DESIGN ADVISORY BOARD Tuesday, April 22, 2014 Conference Room 12, City Hall, Burlington, VT AGENDA

MEMORANDUM

To: The Design Advisory Board
From: Mary O'Neil, AICP, Senior Planner
RE: ZP 14-0884CA/MA 247-249 Pearl Street
Date: April 22, 2014

Request: Redevelopment of site; new three story residential building (approximately 24,000 sf above ground) with 29 units; surface parking to the east and south; retaining walls on east and west.

PROPOSED CONDITIONS SITE PLAN

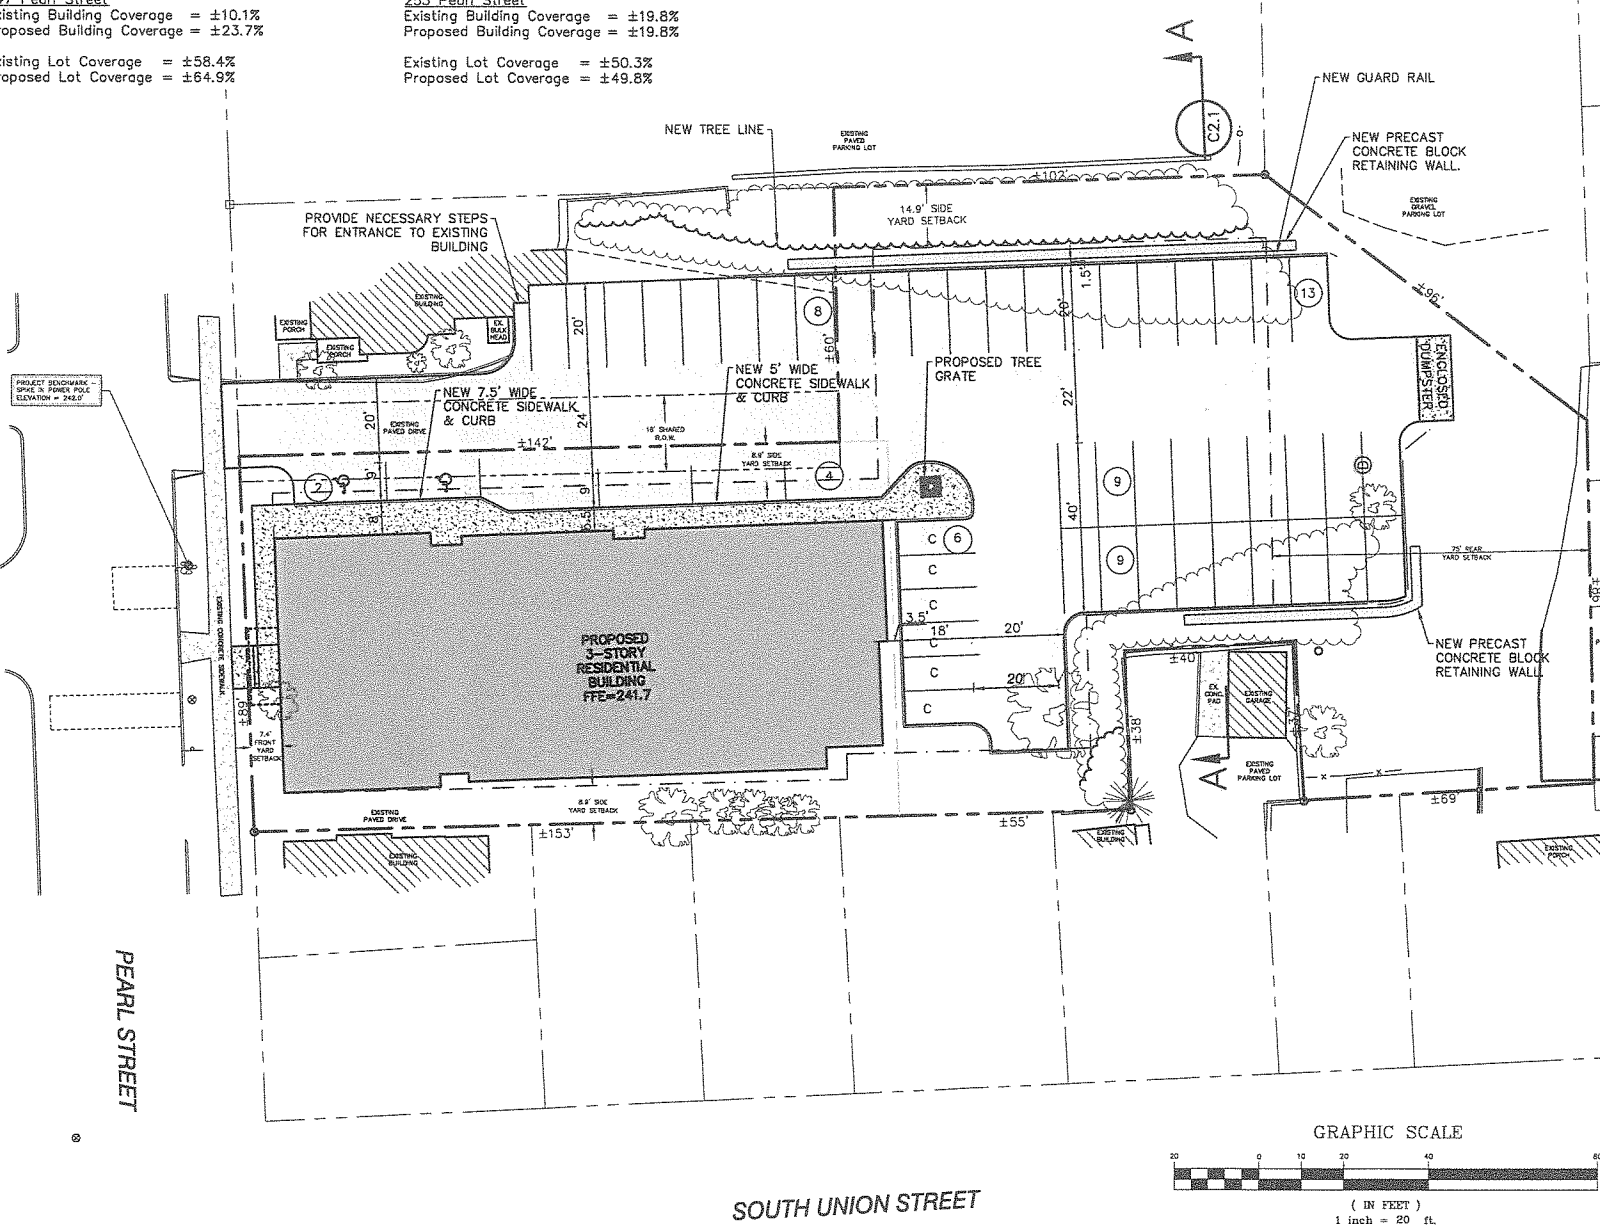
The curb cut appears to be located at the same location as the previous arrangement; just east of this property boundary, and shared with 253-255 Pearl Street. Existing and proposed site plans clearly define proposed changes to the layout and parking for 235 Pearl Street. Any alterations or additions to that parcel will require a separate zoning permit.

This is an existing paved driveway access; and therefore does not enjoy a 5' setback from any property line. The applicant will need to provide evidence of an easement or other instrument that will allow the continued use of the previously shared driveway.

Parking is proposed similar to the previous parking plan, however further encroachment into the easterly bank is illustrated. The parking lot re-grading will cause the elevation to drop approximately 9' from the front of the lot to the rear, where the dumpster has been relocated. A retaining wall is proposed on the east and the west/southerly corner. The precast concrete retaining walls would be an effective parking barrier if they rise above grade. A box beam guard rail is identified on the easterly side of the property. Illustrated as 18" in height (Plan C2.1), the extent of this installation needs to be defined. With larger grade changes (6', in the rear) a higher barrier may be warranted. Approval of the building inspector will be a requirement.

Parking is laid out in a manner that includes tandem parking spaces. The project will be required to comply with Sec. 8.1.14. *(All parking facilities shall be designed to so that each motor vehicle may proceed to and from the parking space provided for it without the moving of any other motor vehicle.)* Presumably the plan may be for each pair to be dedicated to a single unit to allow for tenant-driven valet service for the movement of vehicles; however the second row of parking spaces may not count toward the parking requirement.

Six compact parking spaces are illustrated on the immediate south area of the building. As the dumpster has been relocated, backup and maneuvering is no longer an issue.

A sidewalk is provided along the easterly side of the building. This walkway should be continued along the southerly building elevation to provide access from the compact car parking area to a building entrance.

5. The applicant must provide evidence of continued shared use of the existing driveway prior to redevelopment.
6. Rather than providing conduit for future solar, it is recommended that alternative energies be included within this redevelopment application.

DEPARTMENT OF
PLANNING & ZONING
SHADOW STUDIES

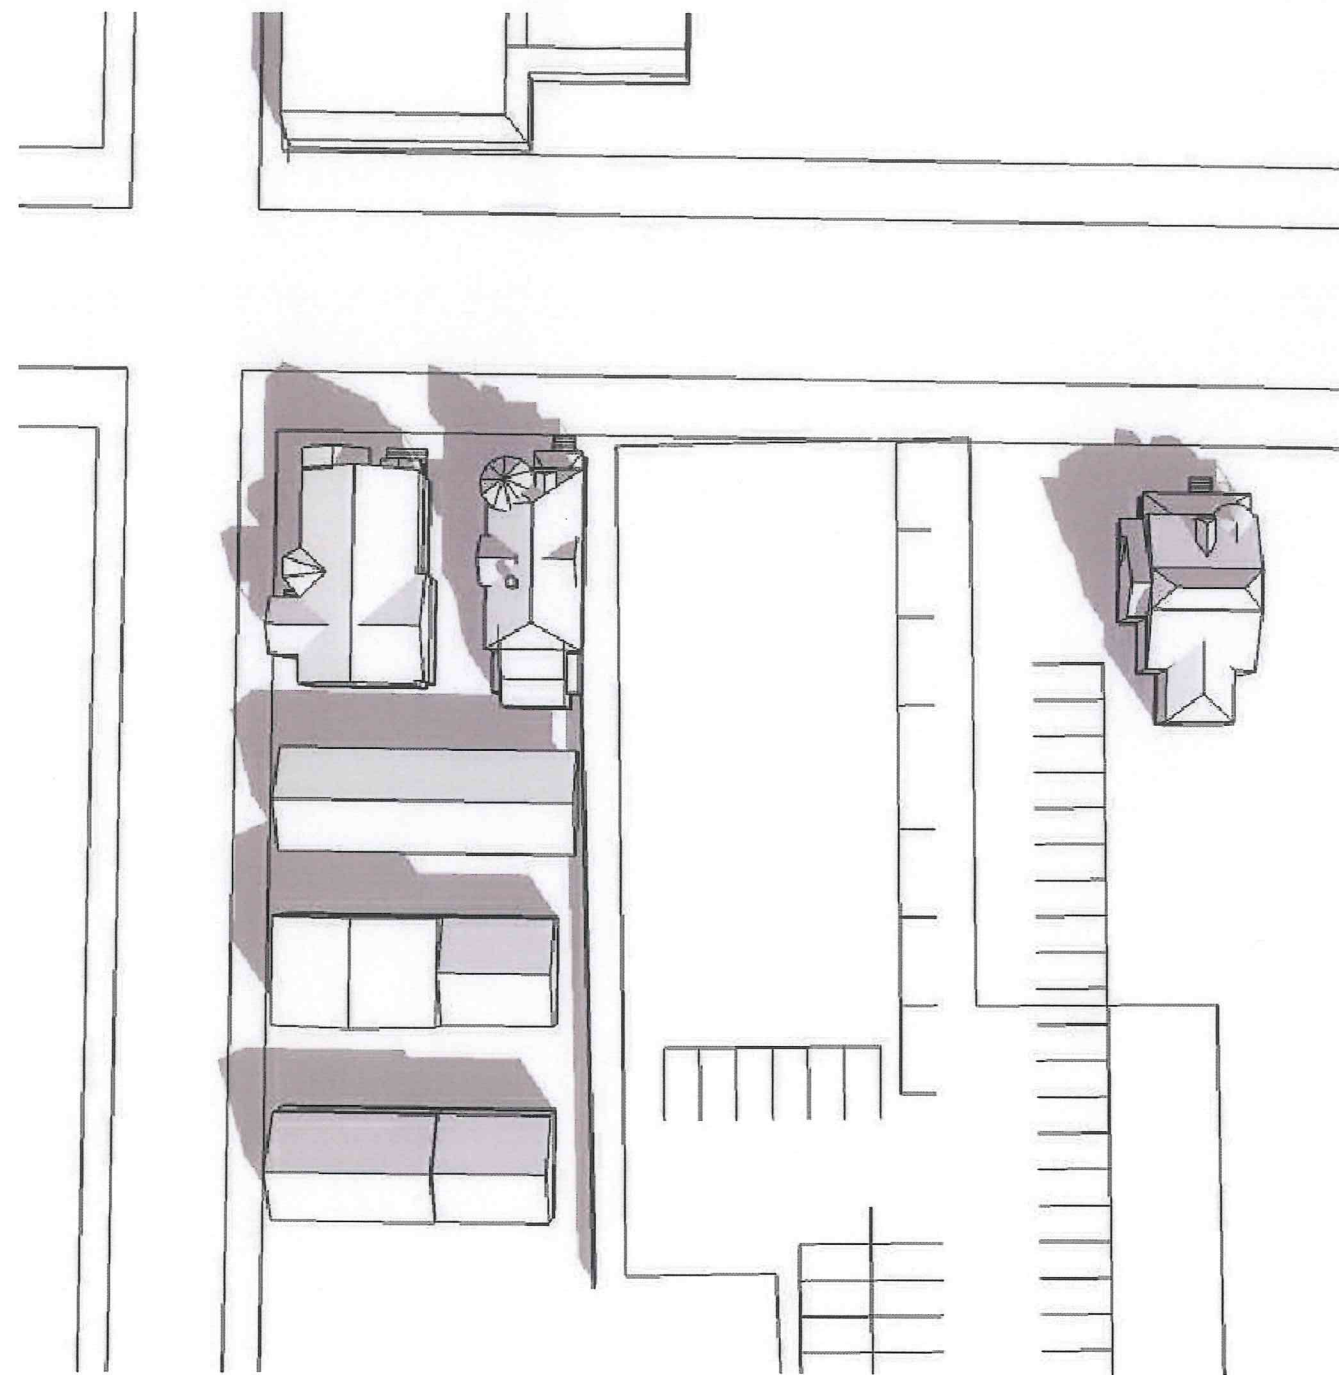
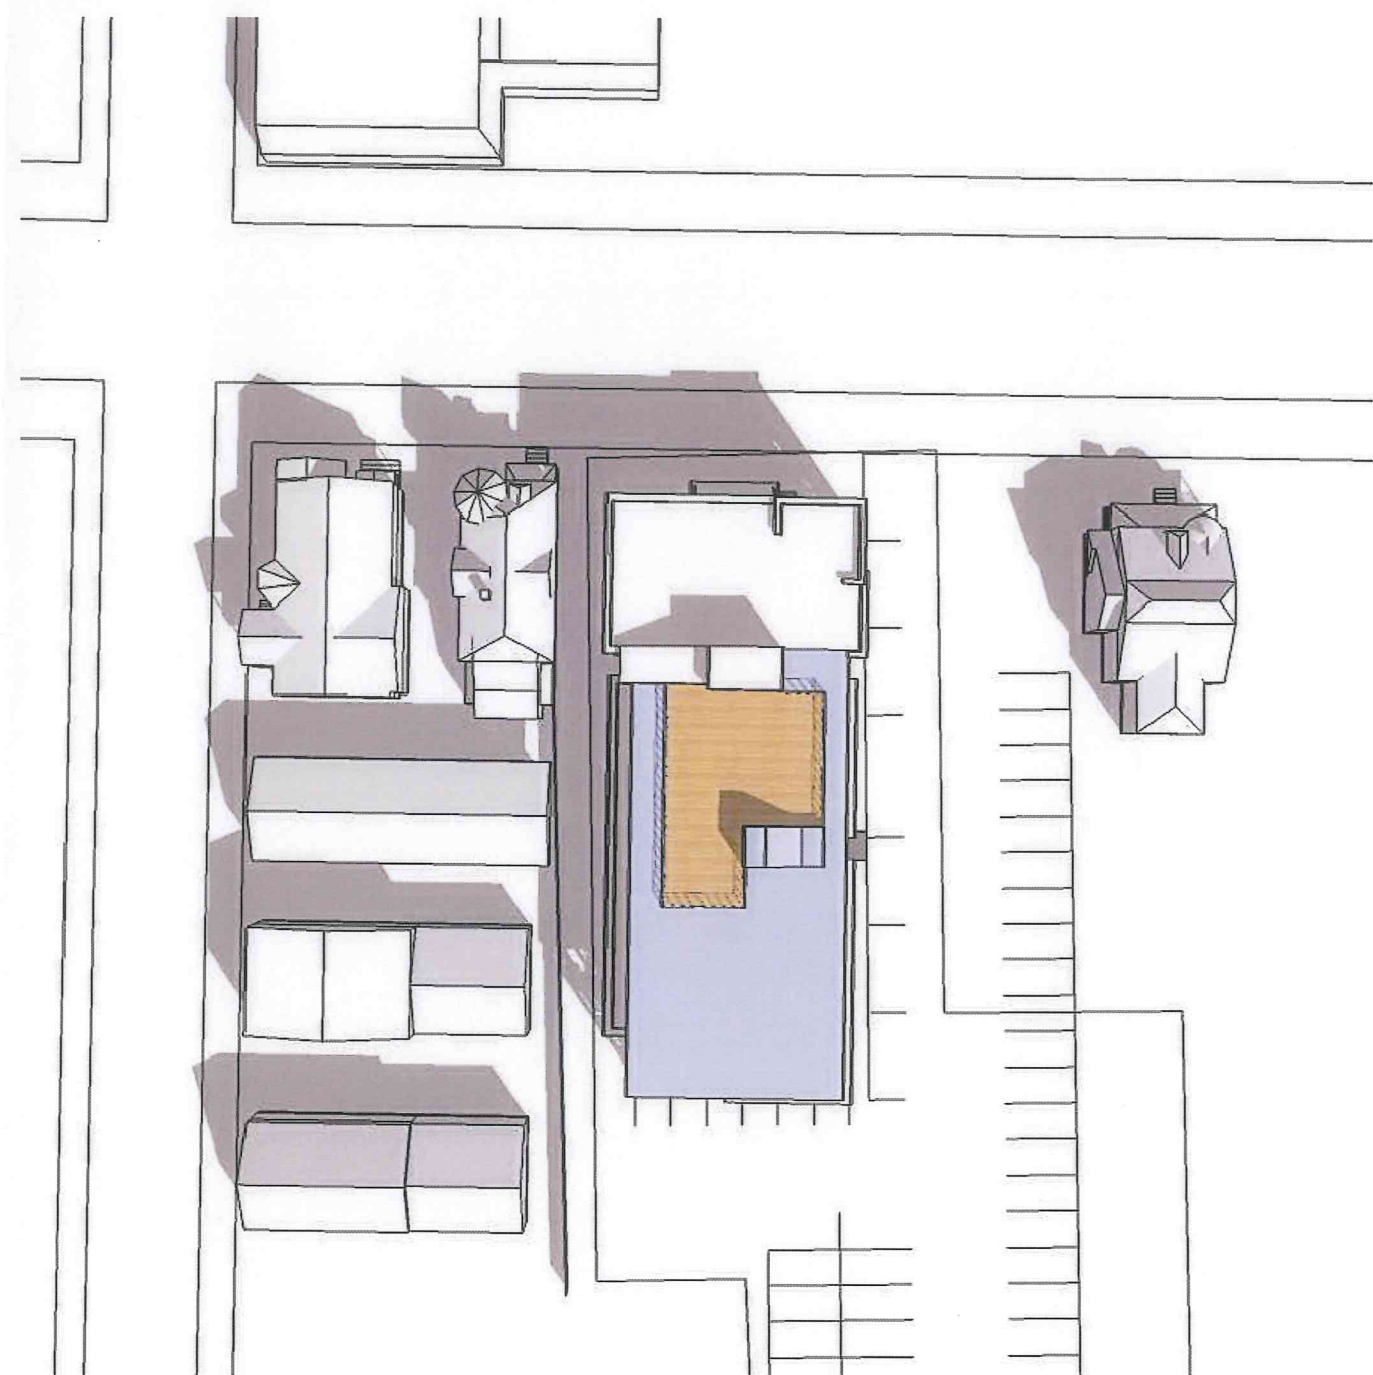
Shadow studies have been submitted for review. See attached study. There will be minor shadow cast in the early morning hours during the autumnal equinox on two houses on South Union Street. This is anticipated and a minor impact, given there was a building here previous to the fire (and only in contrast for having an open lot for more than 2 years.)

change) during the early morning hours of the autumnal equinox. These impacts are not significant. **Affirmative finding.**

PLANTING PLAN

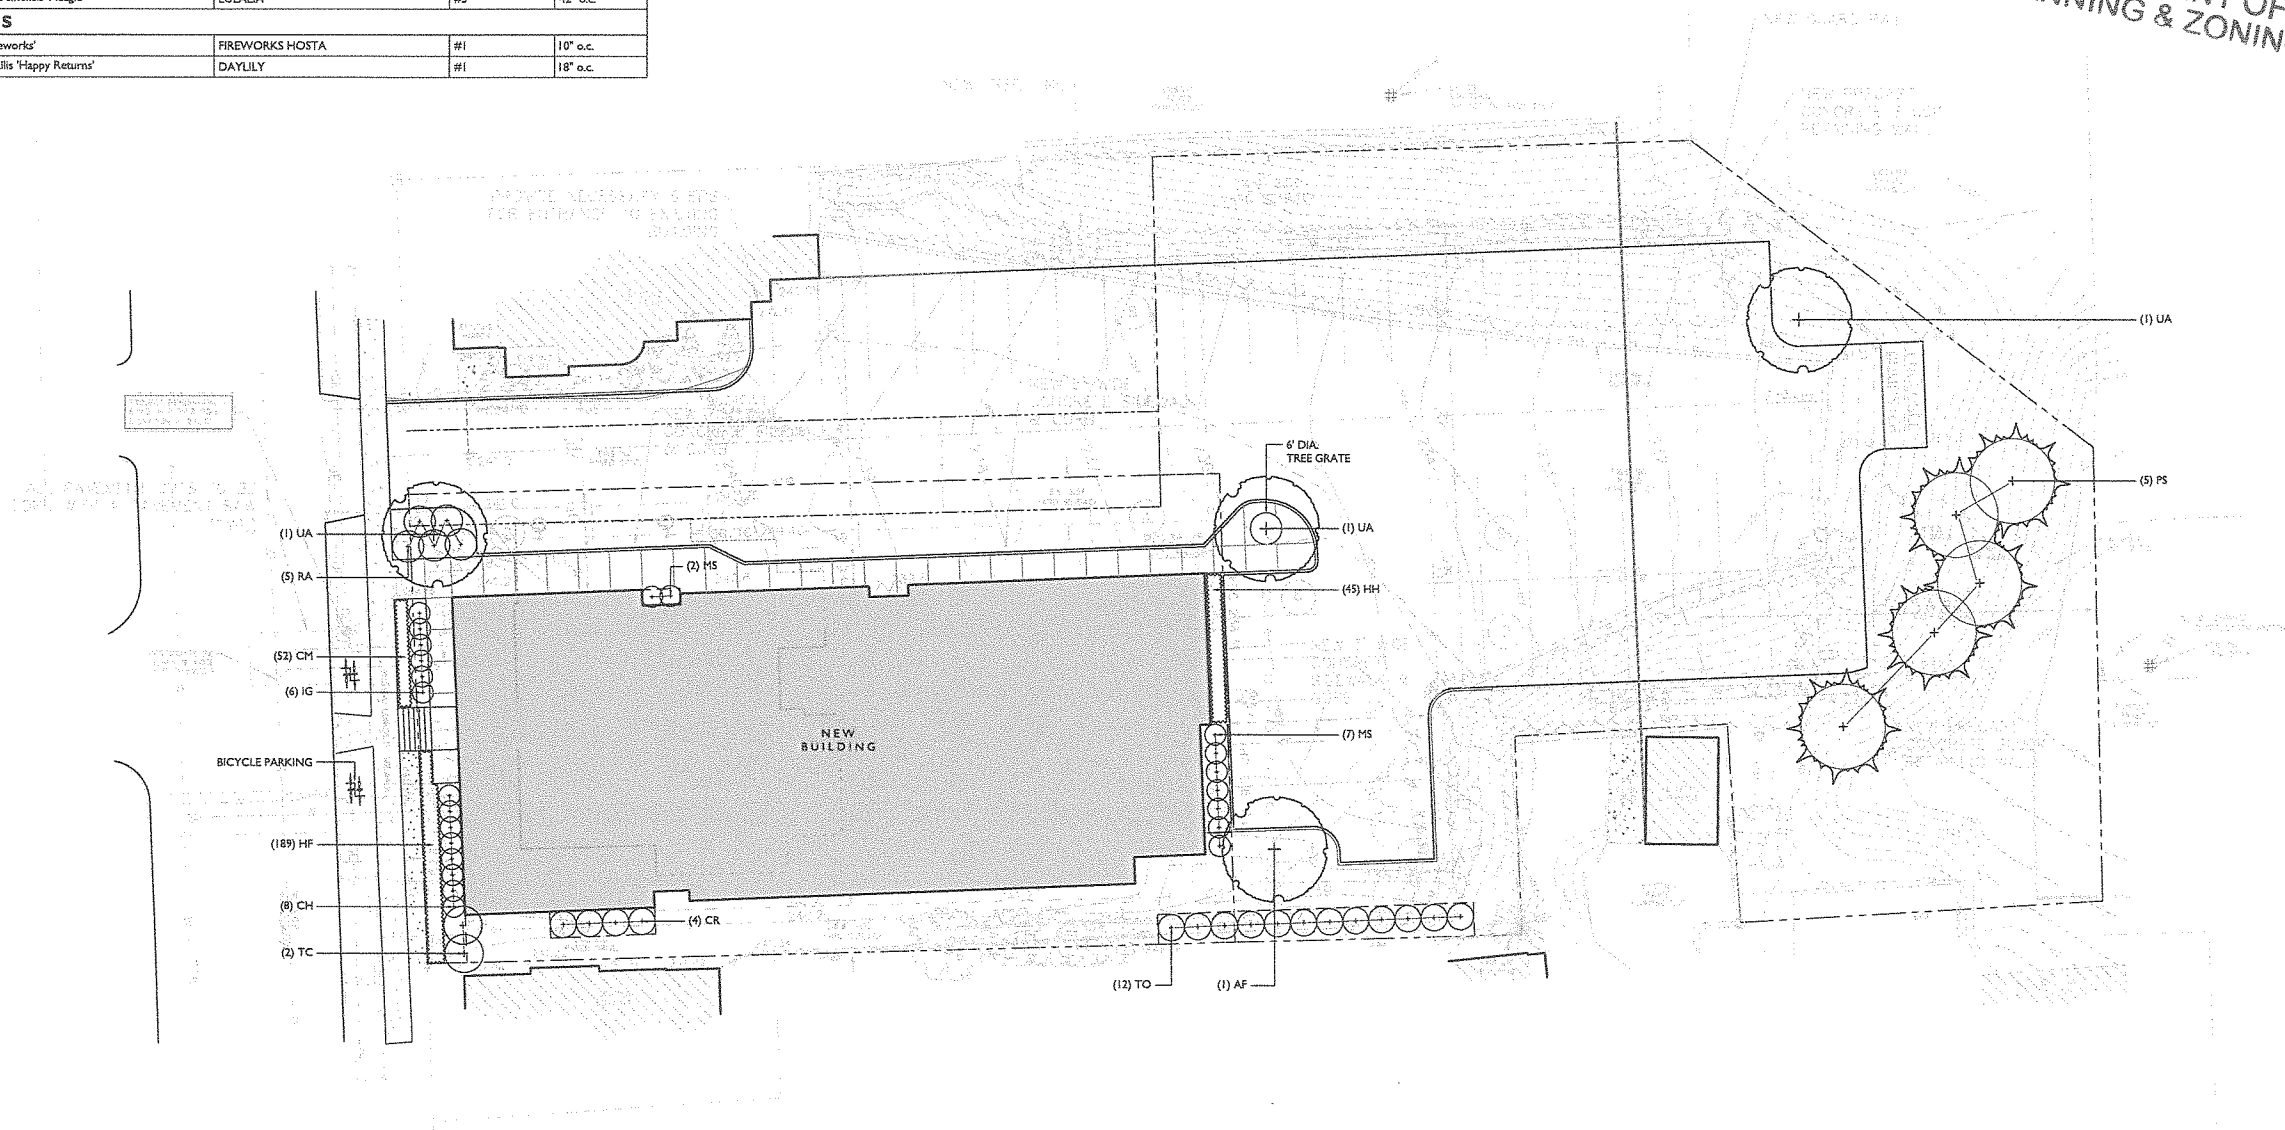
A planting plan has been included within this submission. (Plan L1.0) Parking areas are broken into smaller groups.

The plan will be required to provide 8 trees meeting the above specified minimum caliper to meet the shading standard ($41 / 5 = 8.2$.) Eight trees are illustrated on the planting plan (L1.0).

A planting plan has been provided, defining type, number and location of proposed plantings. An effort has been made to screen the development from the most closely abutting neighbors, and to plant for embankment stabilization and visual screening in the rear. Some alteration to this plan may be required if the walkway circles around the south elevation, as this is a location identified for 7 Eulalia. Any replacement or new trees in the public ROW shall meet with the approval of the City arborist.

8. Eight trees, of a caliber of 2 ½-3" will be required as part of the planting plan, to meet the parking lot shading requirement of Section 6.2.2. (1). *All new shade trees shall be of a species appropriate for such planting environments, expected to provide a mature canopy*
